Access Compliance Report Public Rights-of-Way (Pedestrian Signals)

Main Street: MCFADDEN_AVE Cross Street: BEACH_BLVD Location: SE

ADA ID: SGRK211005145805 Signal Type: One Push Button-APS Overall Compliance: No Severity Scores: BTN 1: 25 BTN 2: N/A No BTN: N/A

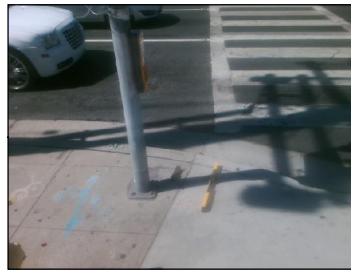
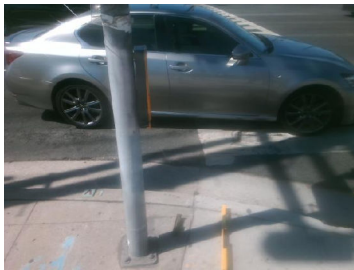
Possible Solutions: Remove and Replace Clear Space.

OC Std/PROW: R404.2
